AMENDMENT NO. 2 MAY 2024
TO
**IS 16192 (PART 3) : 2018 AUTOMOTIVE VEHICLES — WHEEL RIMS FOR TWO
AND THREE WHEELED VEHICLES**
PART 3 SPOKE WHEEL RIMS — METHODS OF TESTS AND REQUIREMENTS

Amendment No. 2 to IS 16192 (Part 3) : 2018

FIG. 1 LOAD APPLYING METHOD

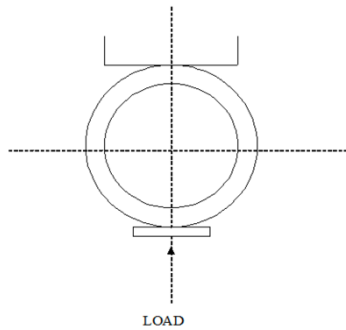
(Page 1, clause 4.2) — Substitute the following for the existing:

4.2.1 Load Applying Method

Place the rim vertically on the base having a plane of not smaller than a horizontal rim width and add the load gradually, as per Fig. 1 to the rim, toward the direction of vertical centre of rim from the most outside circumference part of rim.

4.2.2.1 When the deflection of wheel rims (without wired spokes) has attained a value given in Table 1 by applying a load by the method given in Fig. 1 to the rim, the load shall not be smaller than the value given in Table 2 and in addition, the rim shall be free from cracks.

4.2.2.2 For the sizes not available in Table 1 and Table 2, when the deflection of wheel rims (without wired spokes) has attained a value as declared by wheel rim manufacturer, applying a load by the method given **4.2.1** to the rim, the load shall not be smaller than the value declared by wheel rim manufacturer and in addition, the rim shall be free from cracks.

FIG. 2 CYLINDRICAL BEAD SEAT RIM CONTOURS

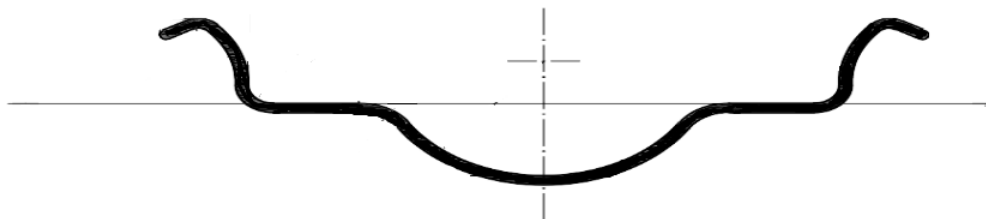
(Page 2, clause 4) — Insert the following after 4 and renumber the subsequent clauses:

5.1 Cylindrical Bead Seat

A rim contour for cylindrical bead seat rim is given at Fig. 2.
